# UNITED STATES PATENT AND TRADEMARK OFFICE

10/799,178

<b>Office Action Summary</b>	<b>Application No.</b> 10/799,178	<b>Applicant(s)</b> FERGUSON ET AL.	
	<b>Examiner</b> Anu Ramana	<b>Art Unit</b> 3775

**DETAILED ACTION*****Double Patenting***

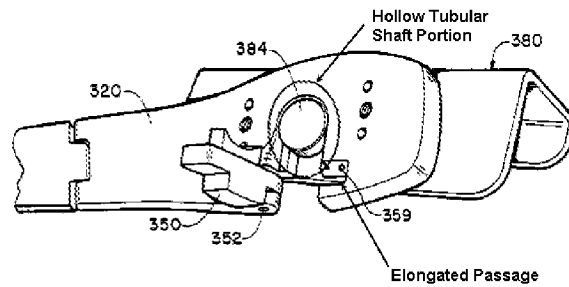
Regarding the limitation, "hollow tubular shaft portion" Wright clearly discloses this feature as illustrated on the following page. It is noted that a hollow tubular shaft portion is any portion that resembles a hollow tubular shaft.
